PRAIRIE CREEK MINE DEVELOPERS ASSESSMENT REPORT

ADDENDUM

Environmental Assessment of
Prairie Creek Mine EA 0809-002

May 2010

FIGURE 1:

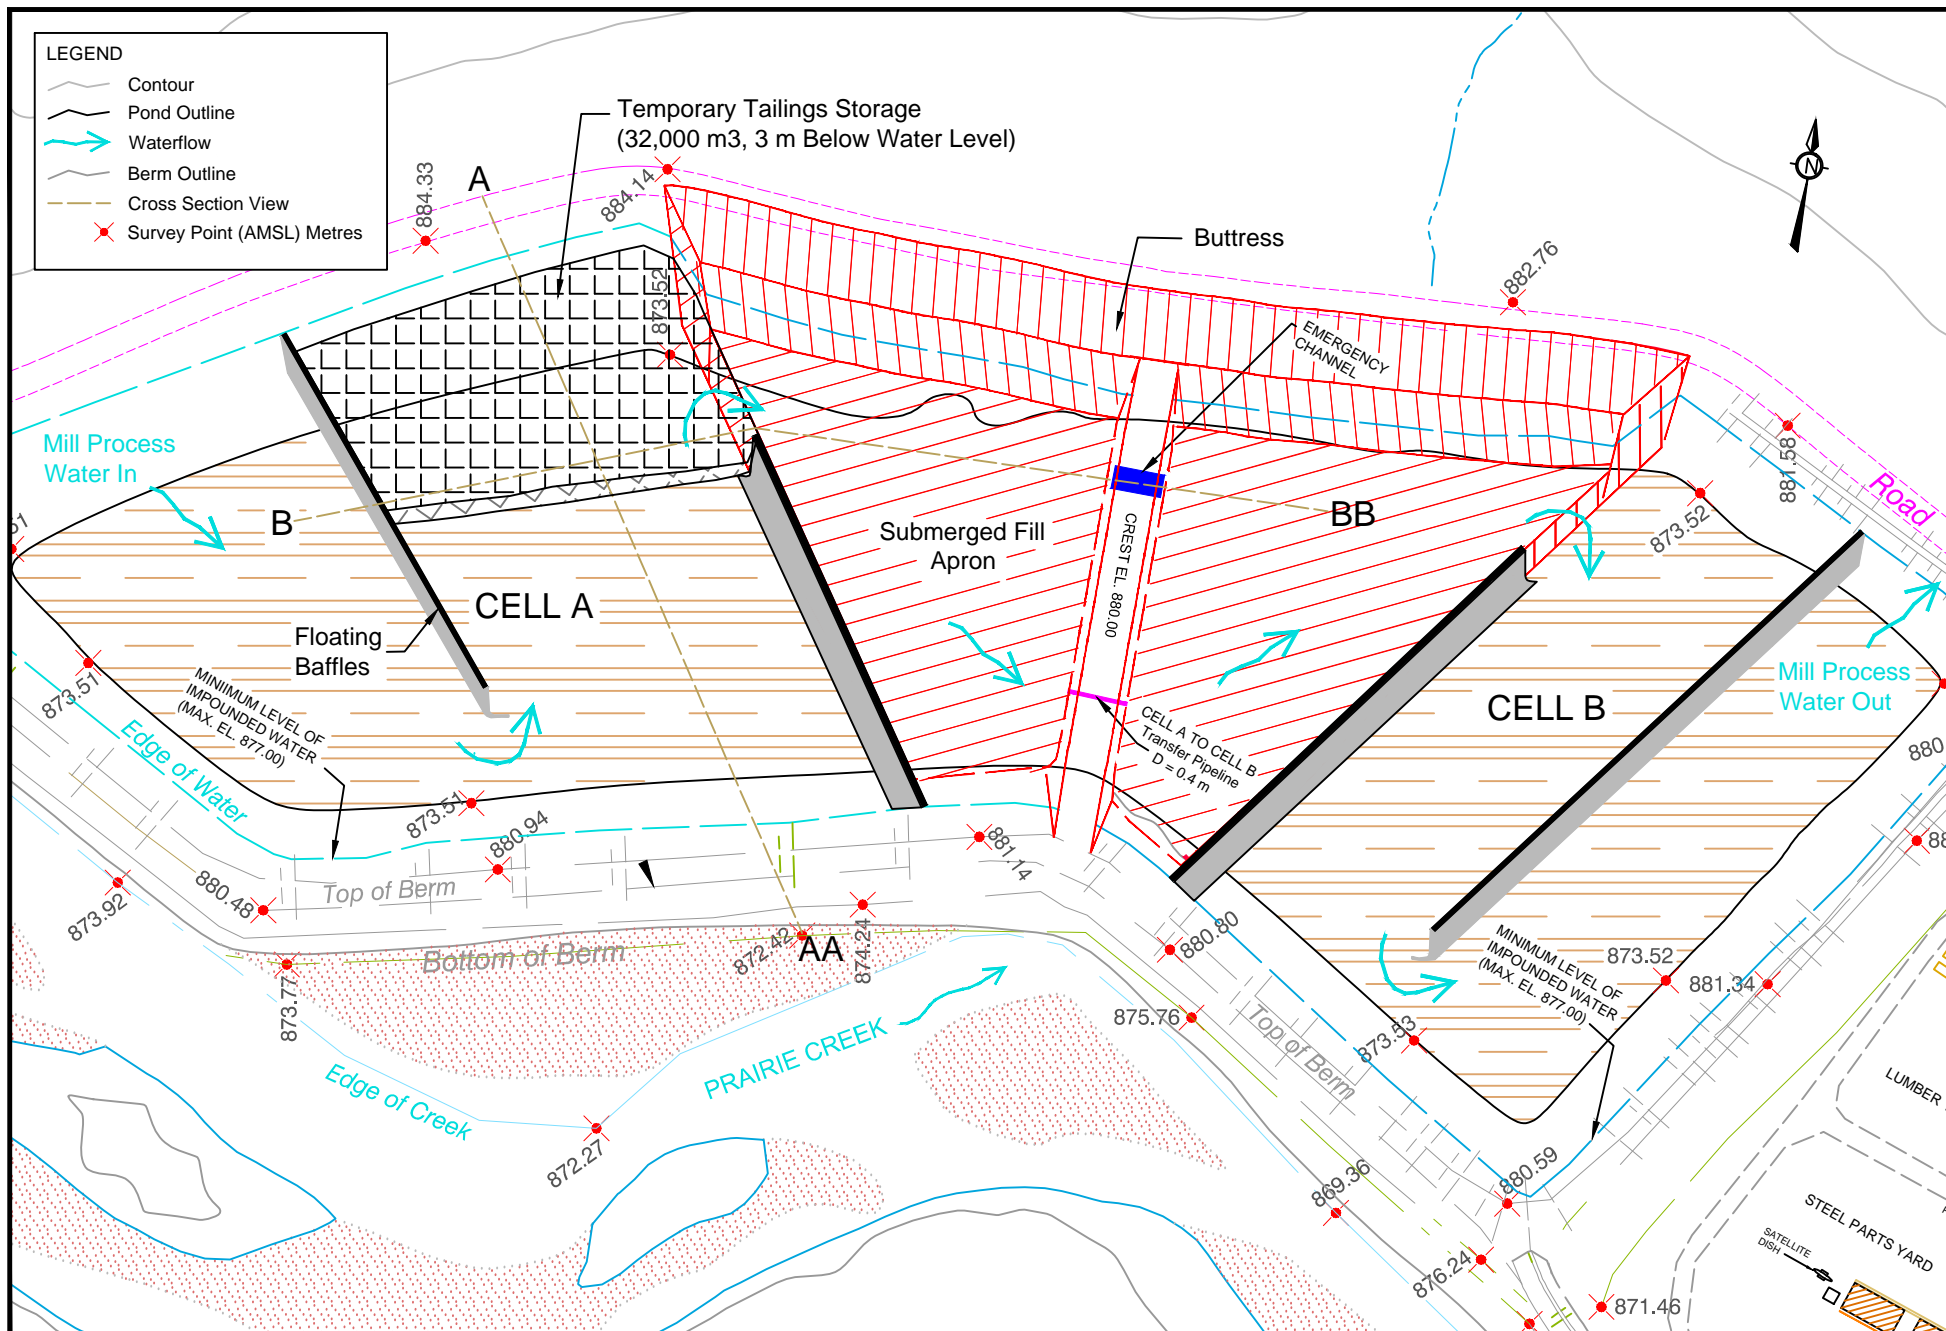
As described in Section 6.3.7 of the DAR, the former tailings pond will be converted into a water storage pond. This water storage pond is later identified briefly in Section 6.12.2 and in Appendix 12 as a temporary storage site for mill tailings. Temporary storage of tailings in the water storage pond instead of on surface adjacent to the pond as originally proposed in the Project Description is an important change in project design. No mention is made of temporary tailings storage in the water storage pond in Table 6-2 or Section 6.3.7 of the DAR. Please describe use of the water storage pond as a location for the temporary storage of tailings. Specifically, please provide details on:

- volume of tailings to be stored in the water storage pond;
- method of tailings transport to the pond and method of tailings placement in the pond;
- location of tailings storage in pond identified on a figure in plan view and cross section;
- duration of tailings storage in the pond;
- method of tailings removal from the pond with predicted ability to remove all temporarily stored tailings; and
- impacts of temporary placement of tailings in storage pond on pond water quality in ToR Section 3.3.2.

The volume of tailings for temporary storage will be approximately 32,000 m³. This represents only 7% of pond capacity. Thus, the quantity of tailings involved is small by comparison. CZN believes temporary storage of the tailings in the pond as opposed to on an adjacent pad is a superior approach for the following reasons:

Figure 1 shows the intended location of tailings deposition. The tailings would be delivered to the WSP through an existing tailings pipeline. A suitable pipeline currently exists on the flood protection berm adjacent to Prairie Creek. The pipeline will be relocated to the north side of the pond. The line would deliver the tailings as a pumped slurry to below the pond water level. The discharge point would be moved periodically to deposit tailings evenly along the submerged slope. The line would be independent of the lines normally carrying mine water and used mill water to the WSP. The tailings will be contained within the intended placement location by the use of a strategically positioned baffle to the west, and the fill apron for slope stabilization to the east. On the west and south sides, a 2 m high toe berm will be built to assist with tailings containment (see cross-sections in Figure 2). As shown on the figure, the direction of pond water flow in the tailings location will be from south to north, and this will further contain the tailings within the proposed location.

The base of the WSP is approximately at elevation 869 m. The tailings will be placed to create a layer up to 5 m thick to elevation 874 m, the same elevation as the planned adjacent fill apron. Elevation 874 m will be 3 m lower than the minimum pond water level. While the fill apron and tailings toe berms will be below a new geosynthetic liner to be installed, the tailings will be deposited on top of the liner.
